Technical Service Bulletin

01 MIL on, DTC P218100, P017B00, P308100, and/or P01E400 are stored in the ECM

01 20 65 2058767/5 June 8, 2020. Supersedes Technical Service Bulletin Group 01 number 20-63 dated May 18, 2020 for reasons listed below.

Figure 1. Gap between chamber and seal.

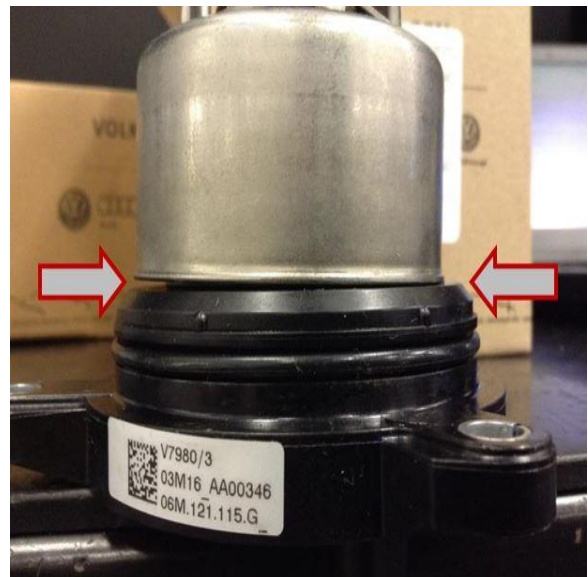
1. Remove the thermostat and check whether it closes completely. If the coolant is still warm, put the thermostat in cold water to restore its original condition. If there is a gap between chamber and seal, the thermostat is faulty and needs to be replaced.
2. Attach photos to the repair order which clearly shows that the thermostat does not close neatly.

After the repair, fill with G12evo coolant in the coolant circuit.
